Cabinteely Greenway

Stage 1 Road Safety Audit Report

230119-X-90-X-XXX-RP-DBFL-CE-0001

April 2025

Location (S5) – Access to/From the Greenway from Gorta Mona Drive

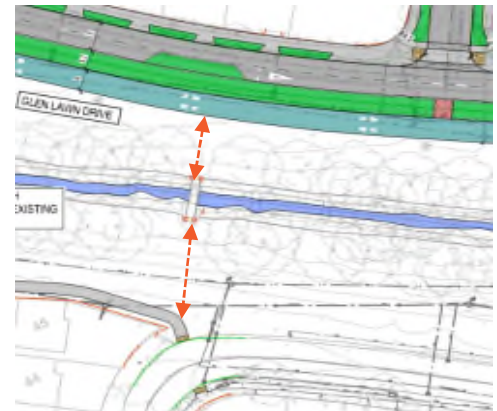
The auditors note that access to/from the Greenway is not provided for users from Gorta Mona Drive. The auditors are concerned that pedestrian or cyclists seeking to access the Greenway via full height kerbs and the grass verge area may result trip/fall type incidents.

It is recommended that safe and convenient access should be provided at this desire line.

Location (S7) – Pedestrian Desire Line at Eastern Arm of Glen Drive Roundabout

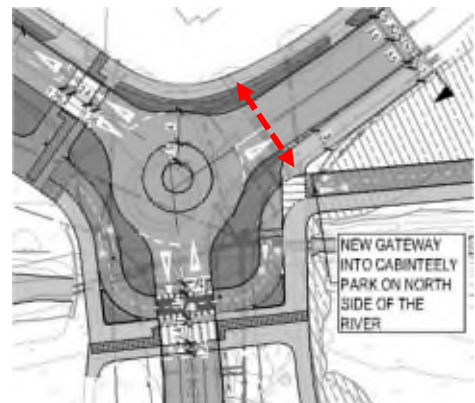
The auditors note that the existing entrance on Glen Drive will be closed and no pedestrian/ facility is provided at the desire line created at the eastern arm of Glen Drive roundabout to cater for Glen Drive residents. The auditors are concerned that pedestrians travelling from dwellings east of the roundabout and along the eastern side of Glen Lawn Dr. to / from the proposed new access into Cabinteely Park may cross Glen Drive along this much shorter route in the path of moving traffic resulting in collisions between vehicles and pedestrians or the proposed Greenway may not be conveniently accessible to some users (wheelchair/push buggy users and visually impaired).

It is recommended that safe and convenient access should be provided at the pedestrian desire line.

Location (S8) – Forward Visibility to Pedestrian Crossing

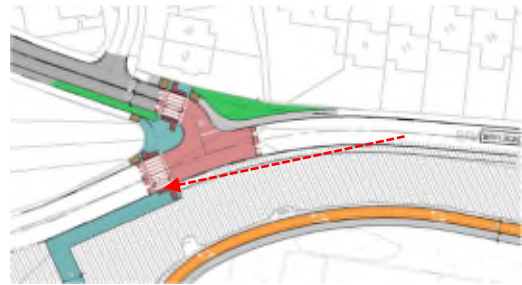
The auditors are unsure if there is sufficient forward visibility provided between westbound drivers and pedestrians at the pedestrian crossing located on Bray Road immediately to the west of Bóthar Chluain Chaoin. Failure to provide sufficient forward visibility between vehicle drivers and pedestrians at the crossing could result in collisions between vehicles/pedestrian/cyclists.

It is recommended that sufficient forward visibility for the desired design speed is provided between drivers and the proposed crossings.
